Subject: West Pasco Class III Landfill, Permit Renewal Application
Responses to Request for Additional Information

GROUND WATER MONITORING PLAN EVALUATION (Rule 62-701.510(9)(b), F.A.C.)

Figure No.1
West Pasco
Class III Landfill
Ground Water Monitoring Wells

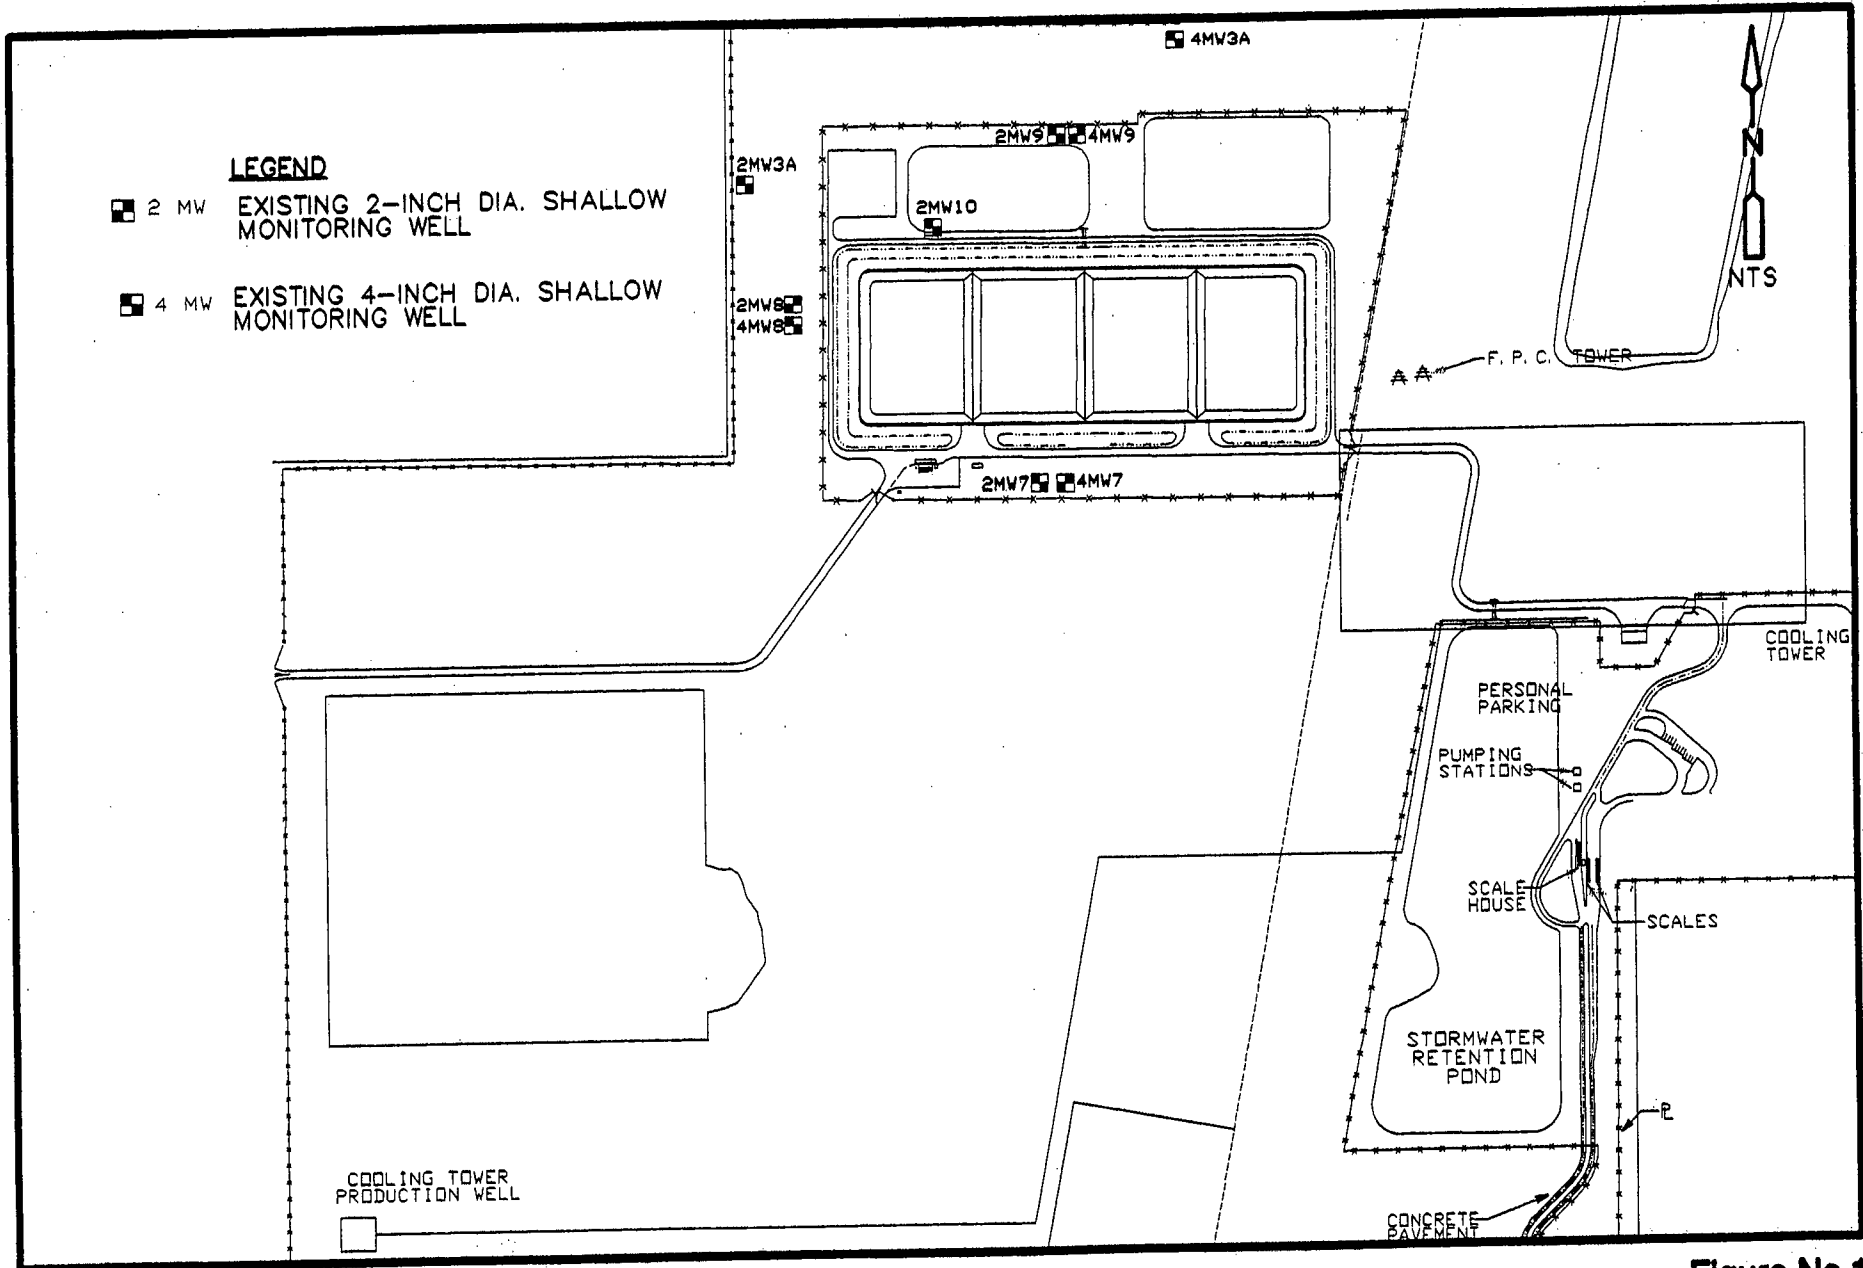
1. The response provided by CDM to clarify the correct identification number for wells 2MW-3/3A and 4MW-3/3A appears to be incomplete. The indication that 2MW-3A is the correct designation is noted, however the response does not clarify

the correct identification number for well 4MW-3/3A. It is noted that the revised Figure 1 (Attachment 5) shows wells 2MW-3 and 4MW-3. Please submit a revised Figure 1 that is consistent with the correct well designations.

Response: The existing monitoring wells 2MW-3 and 4MW-3 should be designated as 2-MW-3A and 4MW-3A respectively. It was confirmed from the Pasco County groundwater monitoring data reports. Provided as Attachment 4 is a revised map showing all existing monitoring wells with correct designations.

Figure 3-1

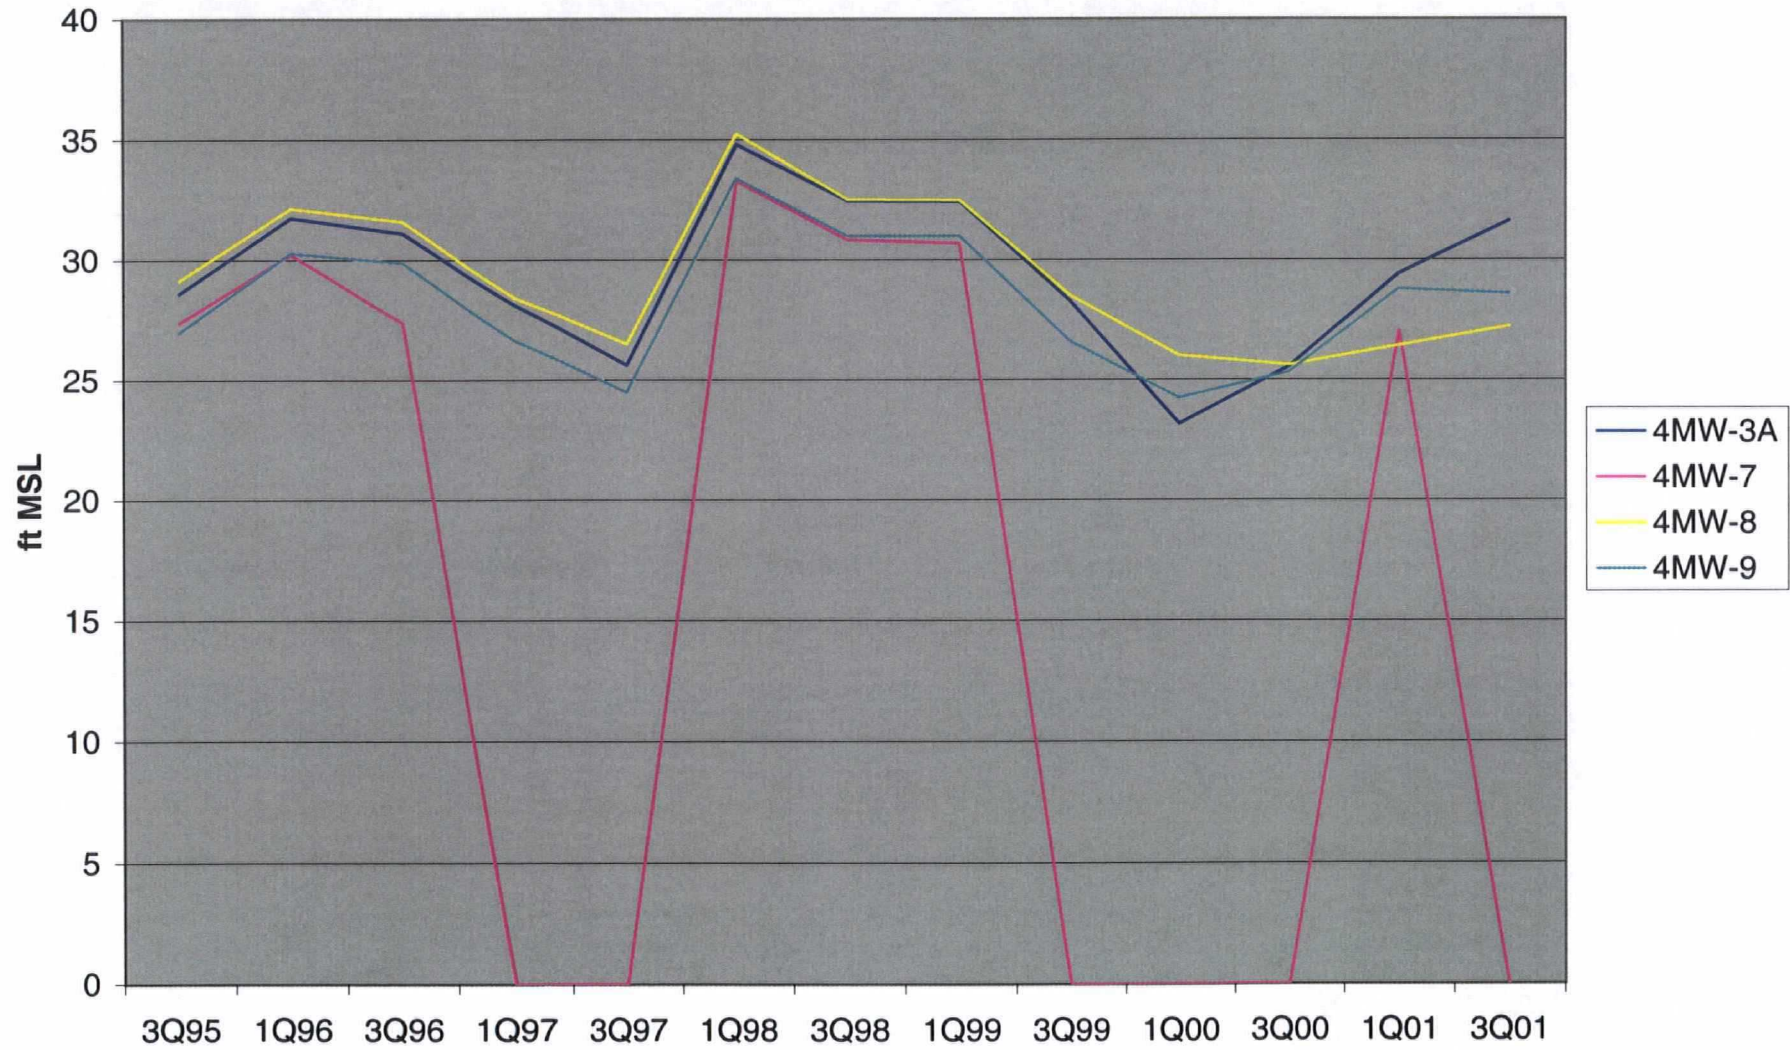
8. Please revise Figure 3-1 to reflect Comment No. 6, above, as appropriate.

Response: Provided as Attachment 7 is a revised Figure 3-1.

Figure No.1
West Pasco
Class III Landfill
Ground Water Monitoring Wells

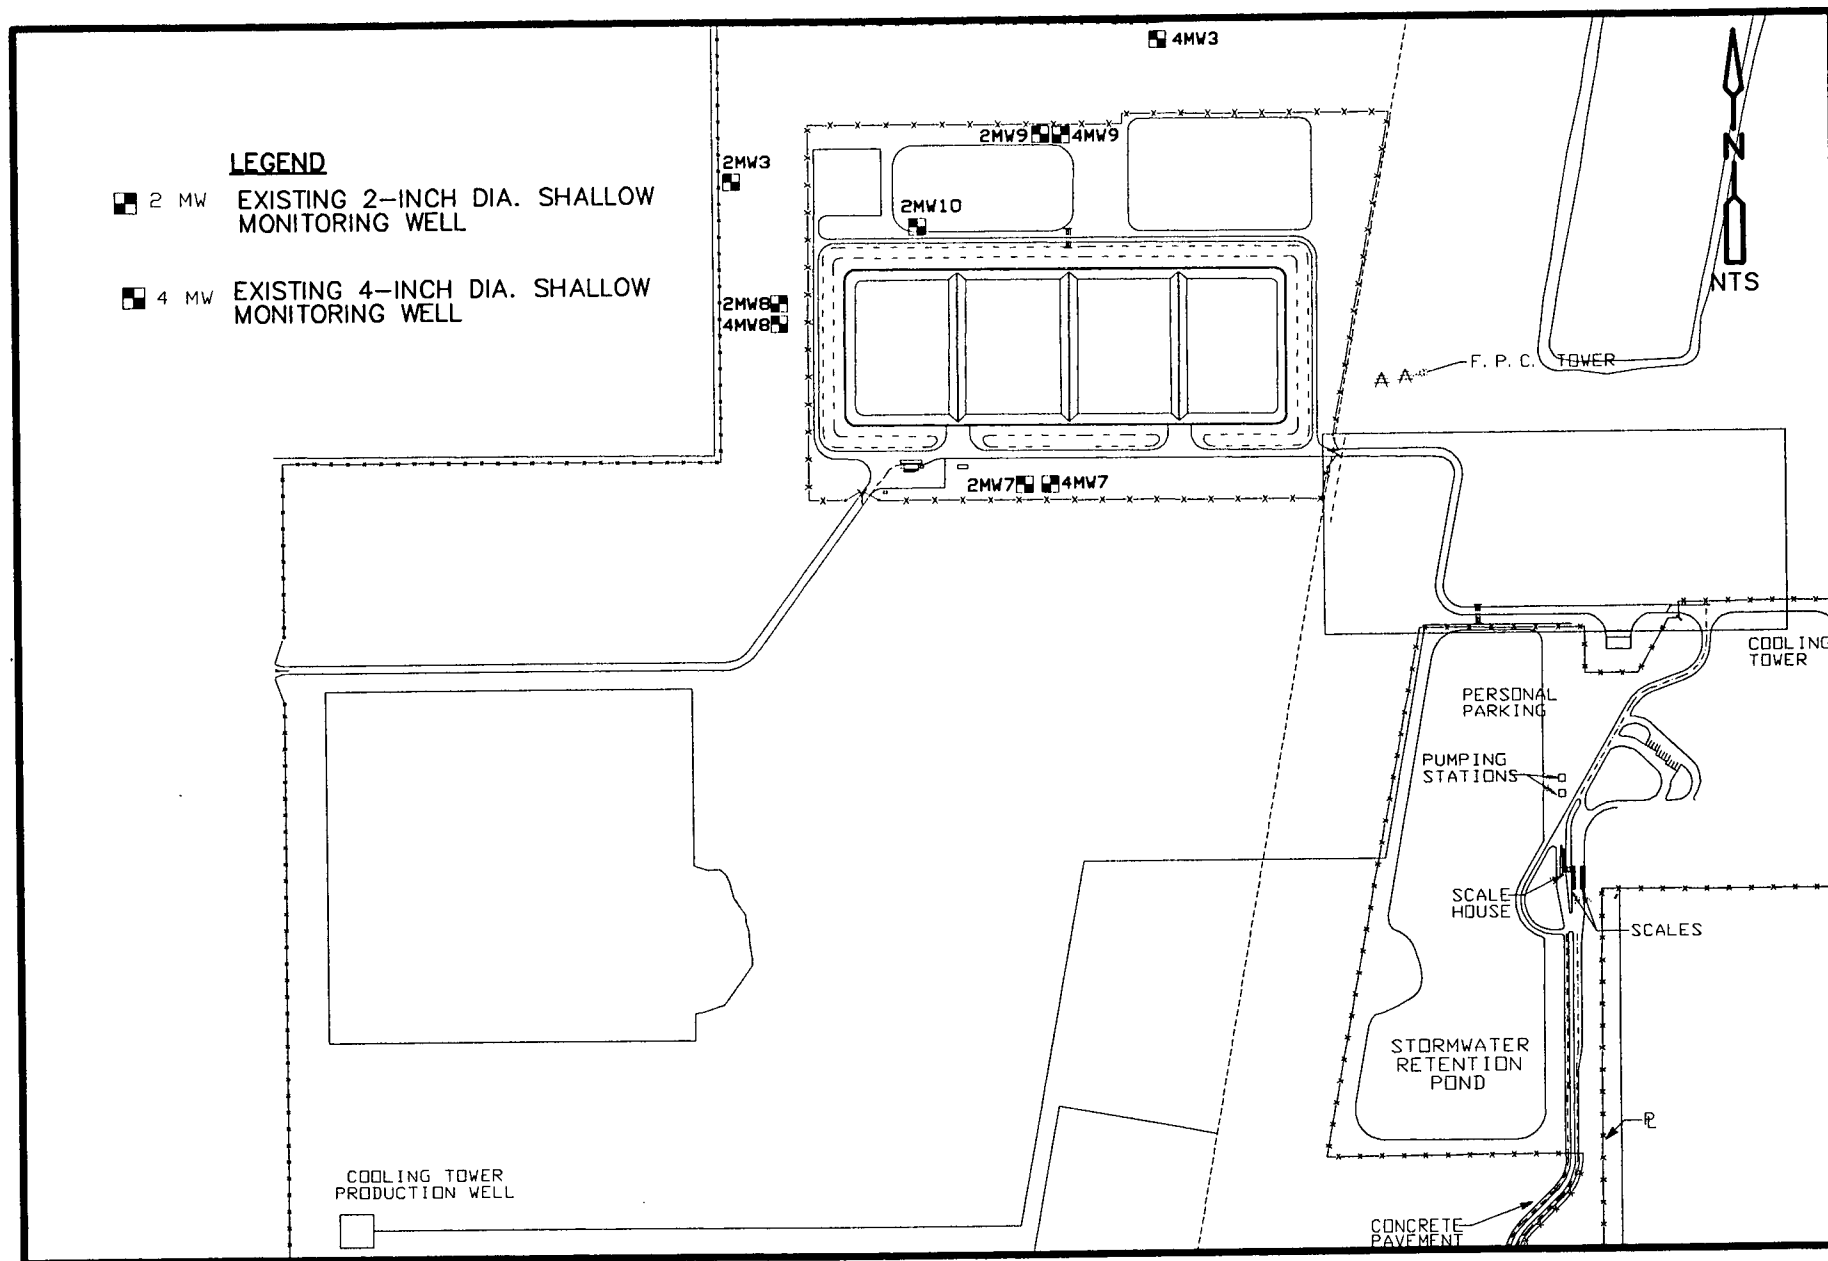
1. Please clarify the identification numbers for two of the existing wells. The CDM submittal references wells 2MW-3 and 4MW-3A, the Pasco County ground water monitoring data reports for the semi-annual sampling events reference wells 2MW-3A and 4MW-3A, and the ground water contour maps prepared by Law Engineering reference wells 2MW-3 and 4MW-3. Please provide a to-scale site map that provides locations for all the existing monitoring wells, the proposed replacement for monitor well 4MW-7, and the supply well for the resource recovery facility cooling tower.

Response: The existing monitoring well 2MW-3 should be designated as 2MW-3A. It was a typing mistake in earlier CDM submittals. It was confirmed from the Pasco County ground water monitoring data reports. Provided as Attachment 5 is map showing all existing monitoring wells and the supply well for the resource recovery facility cooling tower. Qore, Inc. will be contacting you directly regarding the location of the replacement (or repair) for monitoring well 4MW-7.

Figure 2-1
4MW3A

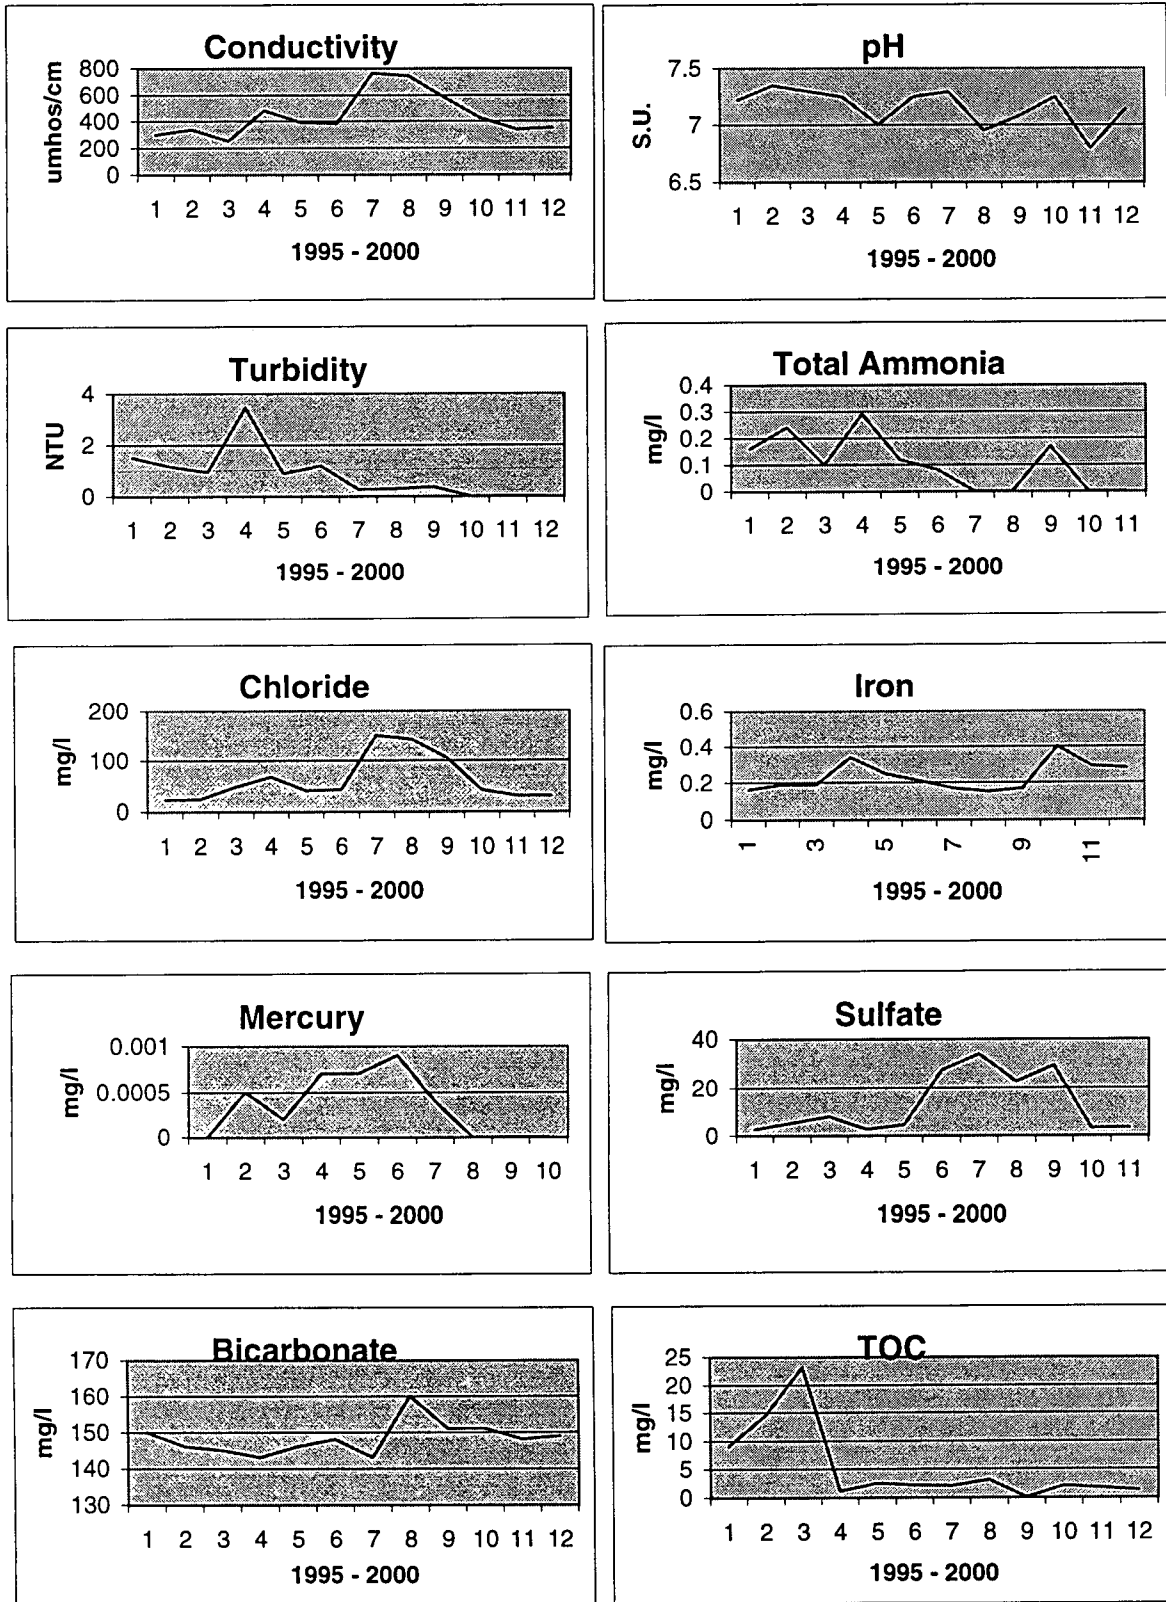
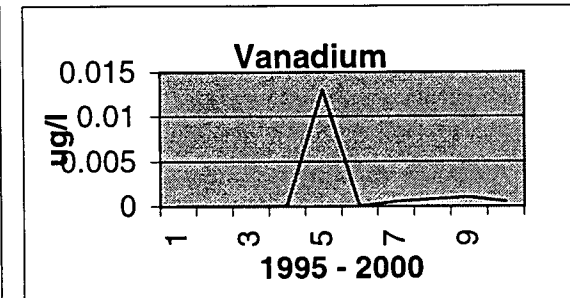
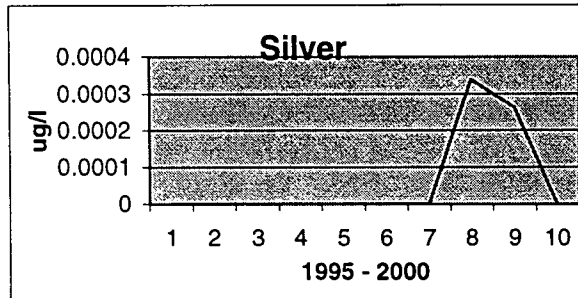
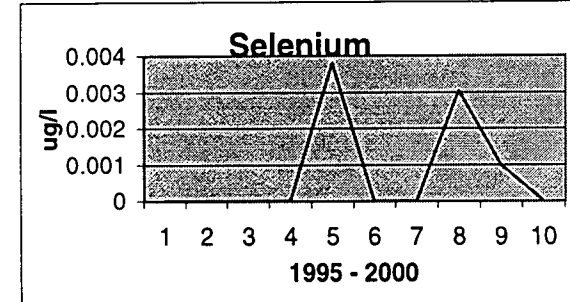
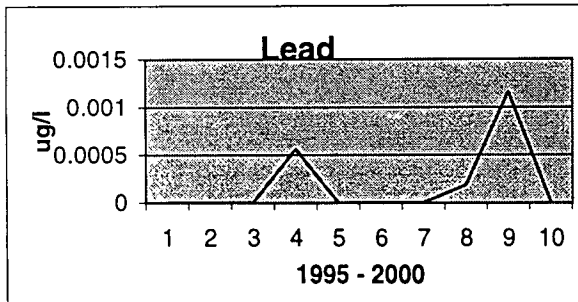
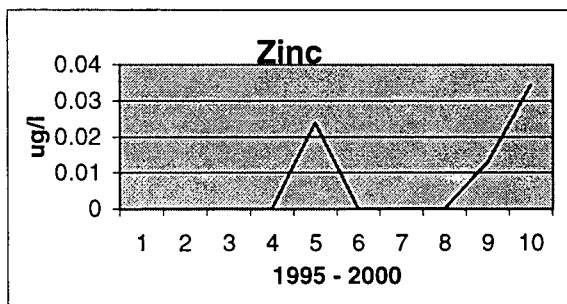
5. The revision to Figure 2-1 provided in Attachment 8 regarding the memory concentration reported for well 4MW-3A for the Quarter 1, 1999 sampling event is noted. **No additional information is required.**

- 5. Please provide a revised Figure 2-1 that reflects the mercury concentration reported for well 4MW-3A for the Quarter 1, 1999 sampling event, as referenced in comment No.2.b. above.

Response: Provided as Attachment 8 to this letter is a revised Figure 2-1 with the requested correction.
